Informal document GRSP-55-21-Rev.1  
(55th GRSP, 19-23 May 2014,  
agenda item 16)

## **Proposal for 03 series of amendments to Regulation No. 94 (Frontal collision)**

**Submitted by the expert from France as Chair of the Informal Working  
Group on Frontal Impact \***

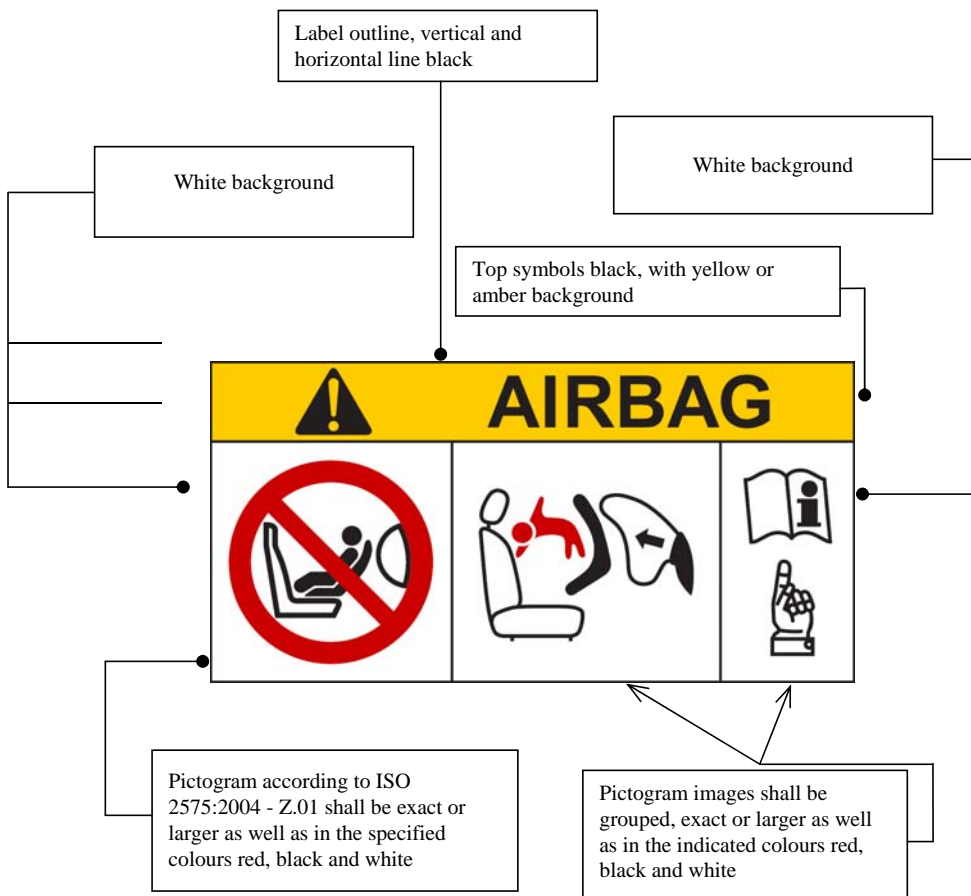
Paragraphs 6.1.2 to 6.2.3, deleted:

~~6.2. A vehicle fitted with one or more passenger frontal protection airbags shall carry information about the extreme hazard associated with the use of rearward facing child restraints on seats equipped with airbag assemblies.~~

~~6.2.1. As a minimum, this information shall consist of a label containing clear warning pictograms as indicated below:~~

Model B  
(See paragraph 4.5. of this Regulation)

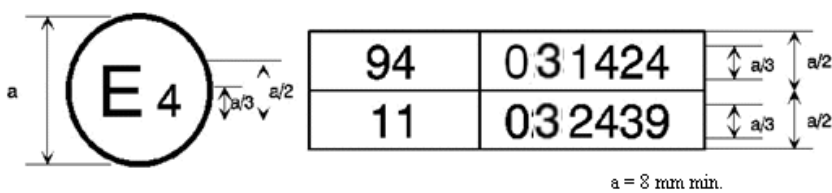
... The first two digits of the approval numbers indicate that, at the dates when the respective approvals were granted, Regulation No. 94 incorporated the 02 03 series of amendments and Regulation No. 11 incorporated the 02 03 series of amendments.
